RE: RPA NORTHWEST PRECINCT REDEVELOPMENT – RESPONSE TO TRAFFIC MATTERS

GTA Consultants has reviewed the traffic, on-site parking and loading matters as they relate to the Royal Prince Alfred Hospital (RPAH) Northwest Precinct Redevelopment and in particular comments by the Department of Infrastructure and Planning (DoPI), the City of Sydney (CoS) and Transport for NSW (TfNSW) in each respective letter of response to the project application (MP 10_0166) dated August 2012.

Attachment A

Brodie Street Shared Zone

CLIENT	SAVILLS (AUST) PTY LTD		
	ROYAL PRINCE ALFRED HOSPITAL - NSW		
	MISSENDEN ROAD, CAMPERDOWN		
	RPA NW PRECINCT REDEVELOPMENT		
	CAR PARK COMPLIANCE CHECK		
SYDWAY REF. 64/P7	DRAWING NO. 12S9008000-08-01	SHEET 1 OF 9	ISSUE P2

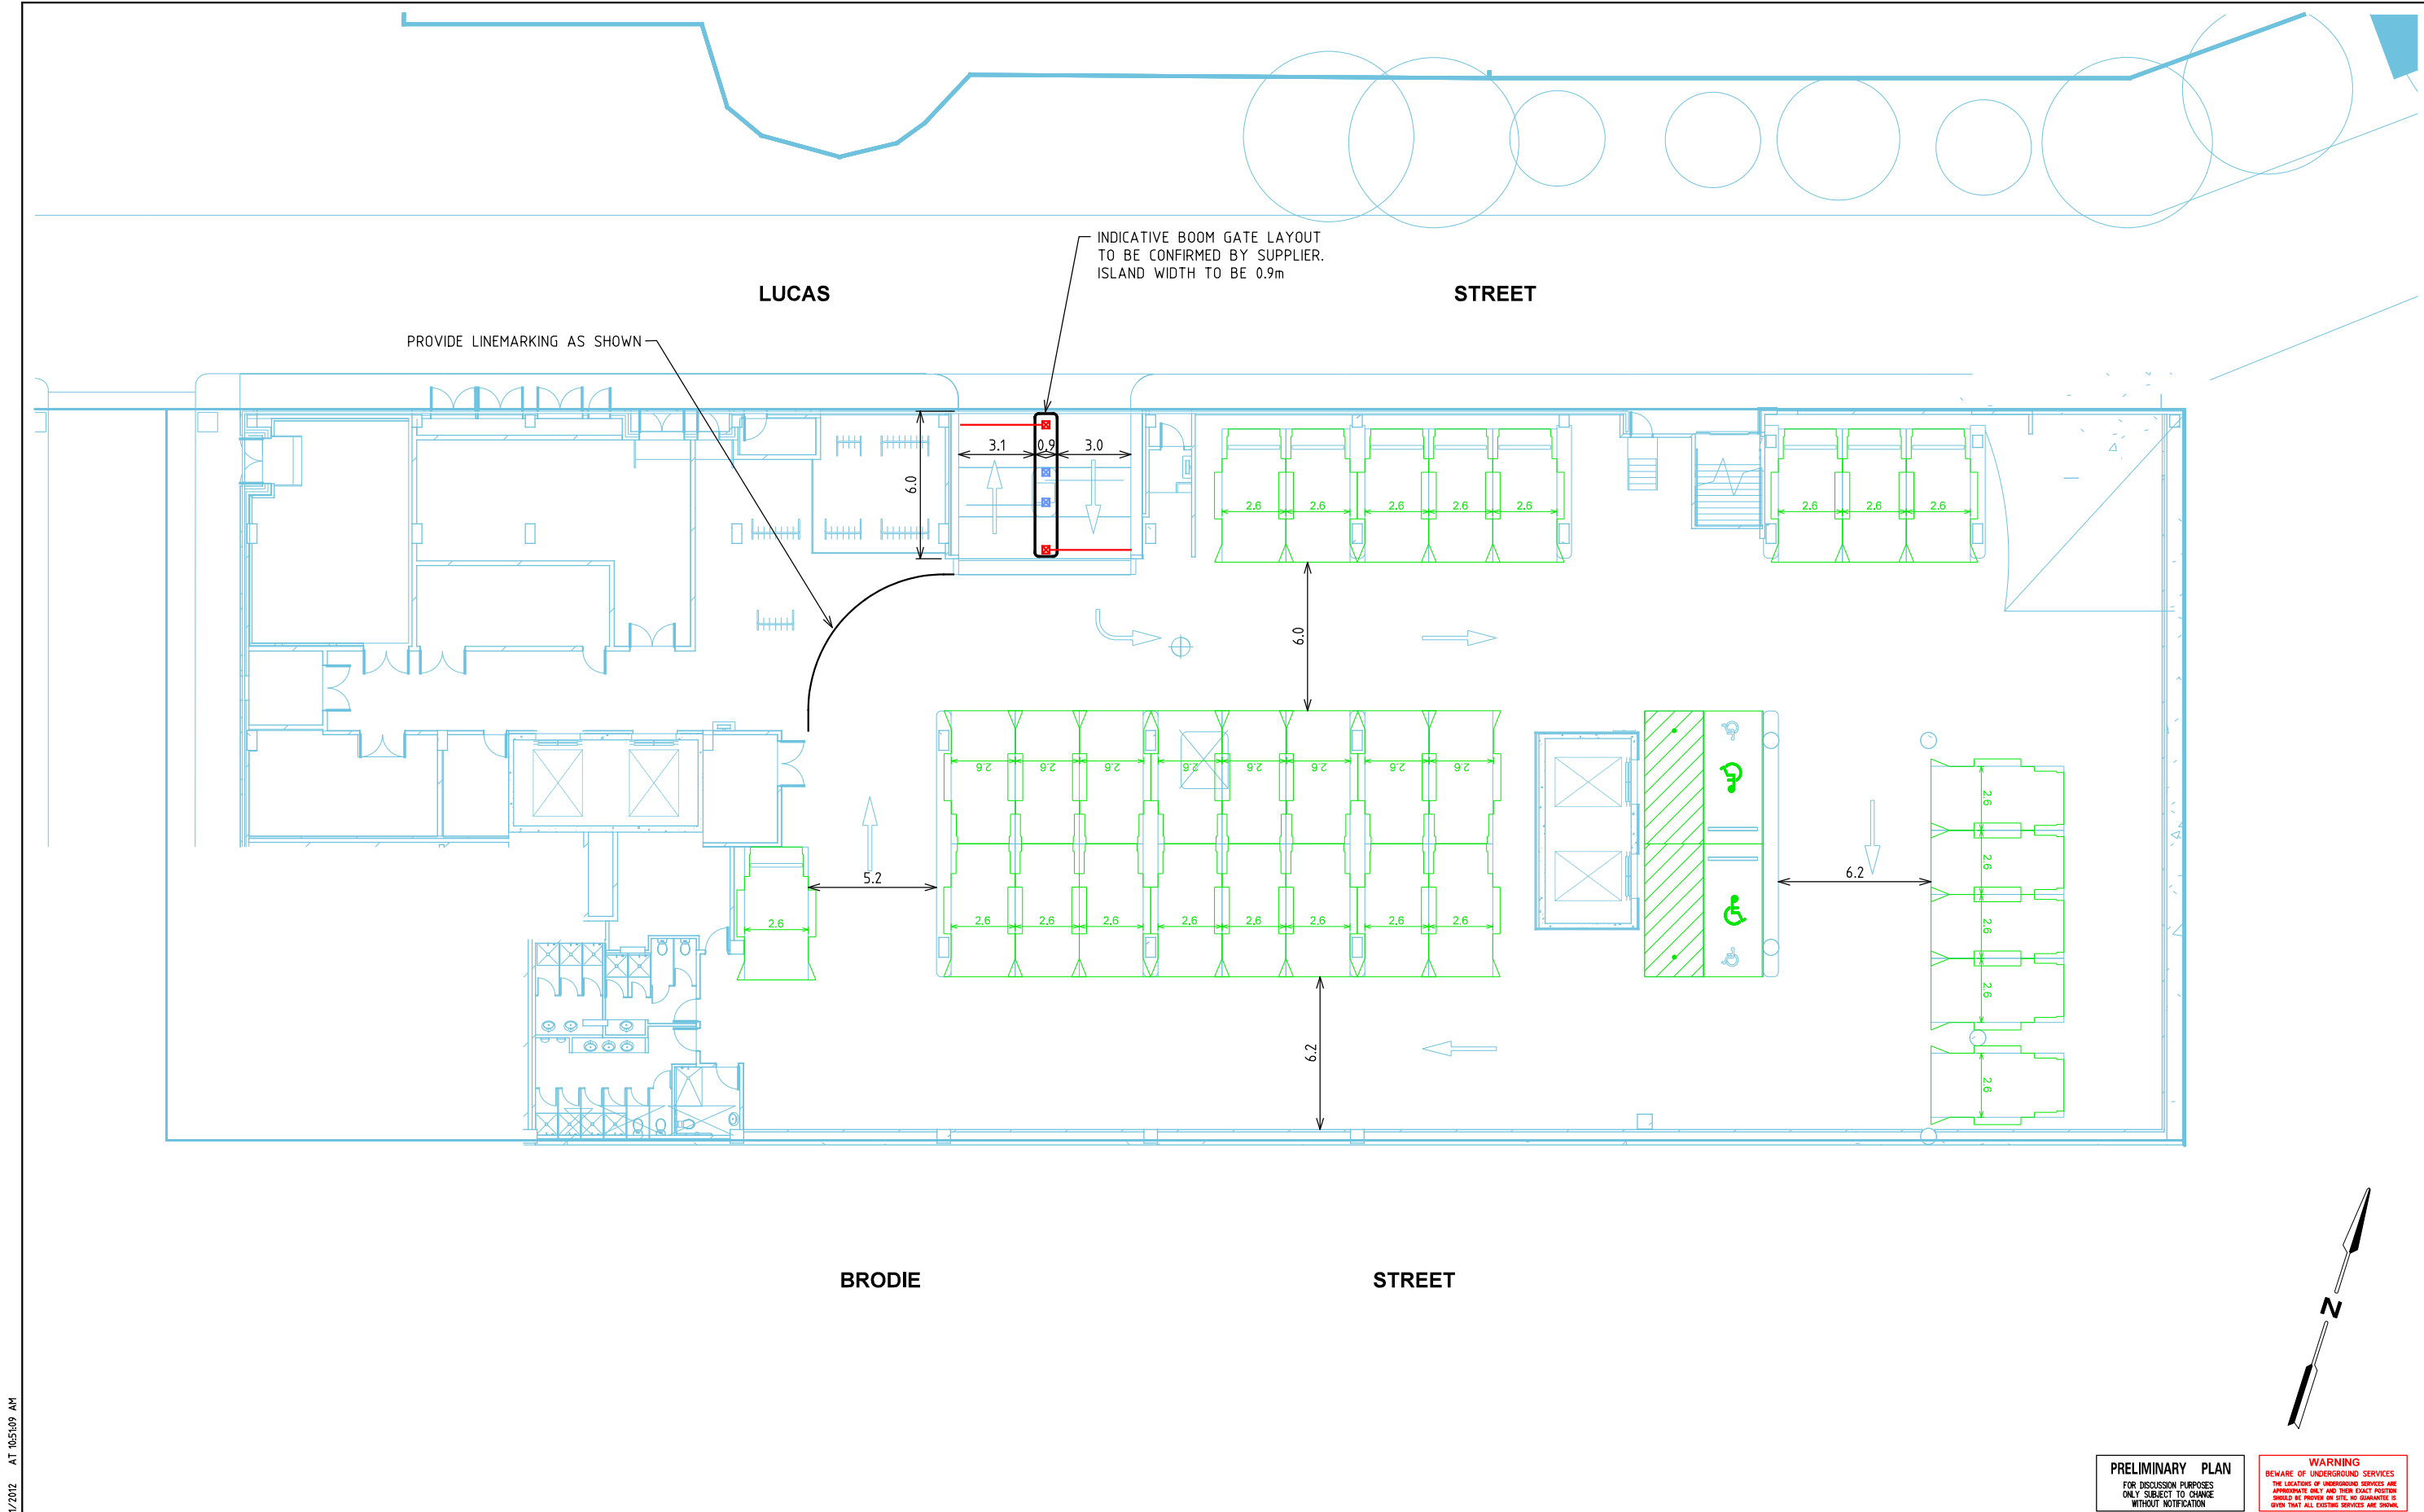
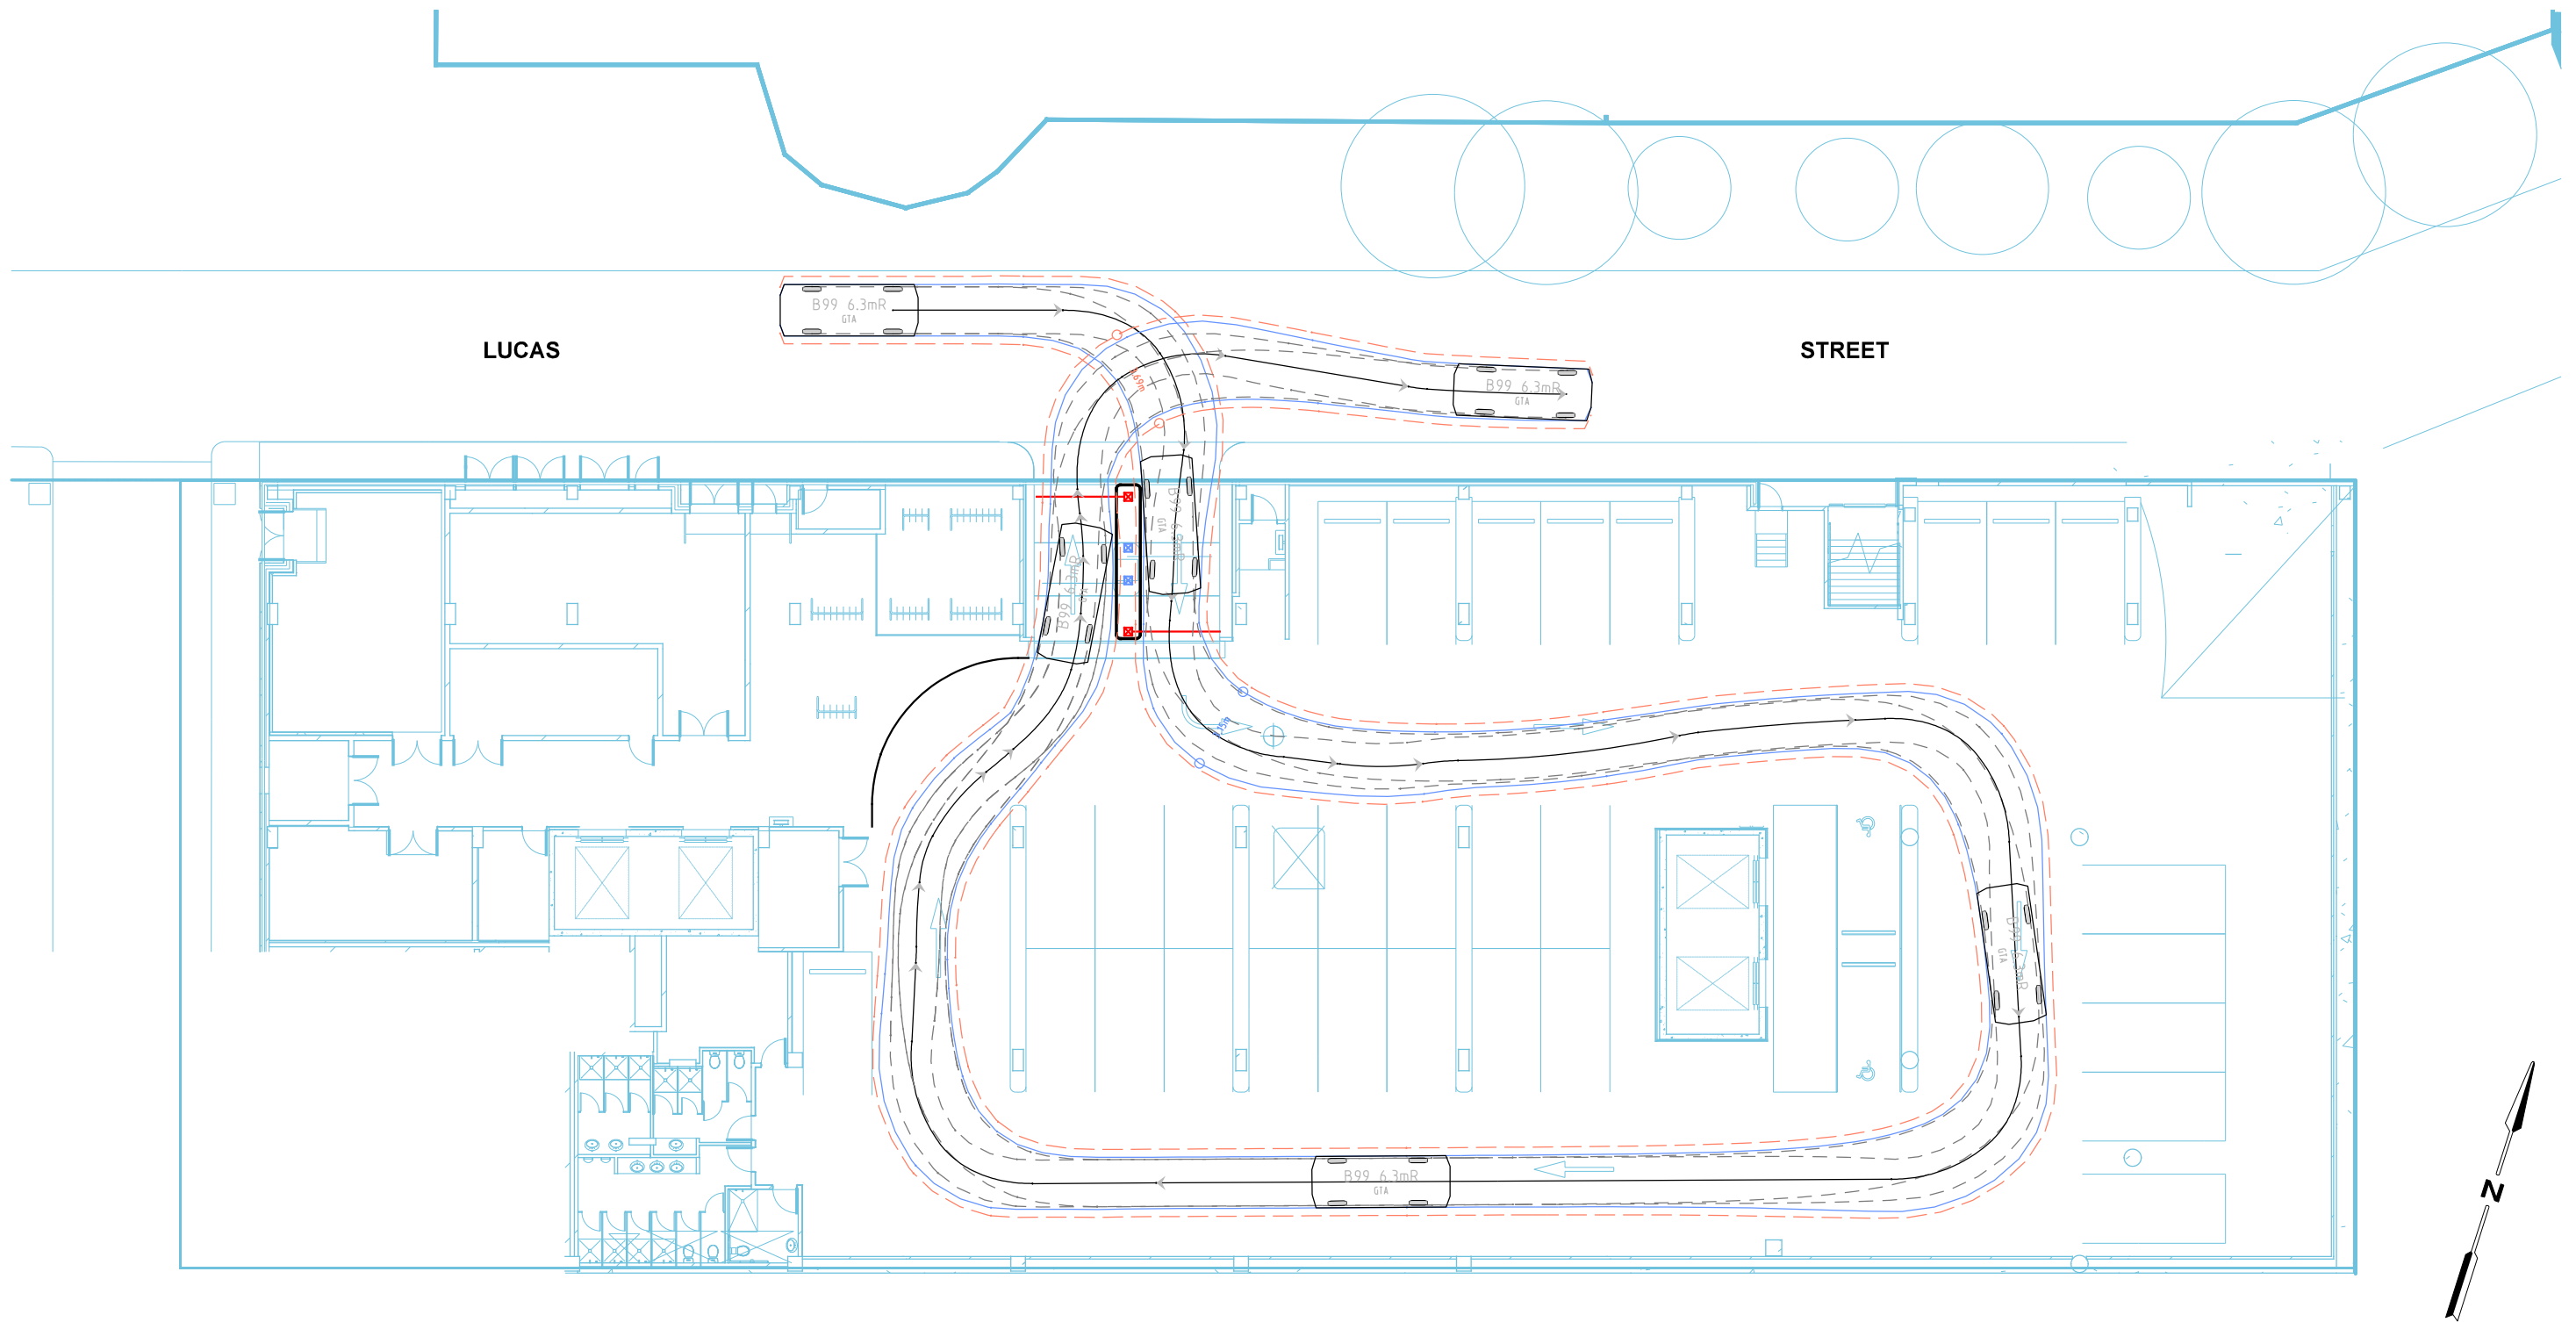
A maximum of 38 off-street car parking spaces must be provided. The design, layout, signage, line marking, lighting and physical controls of all off-street parking facilities must comply with the minimum requirements of Australian Standard AS/NZS 2890.1 - 2004 Parking facilities Part 1: Off-street car parking and Council's Development Control Plan. The details must be submitted to and approved by the Principal Certifying Authority prior to a Construction Certificate being issued.

Noted. The basement level car park provides undercover parking for 32 vehicles and complies with the requirements of AS2890.1:2004. A compliance review and swept paths are included in this response as Attachment B.
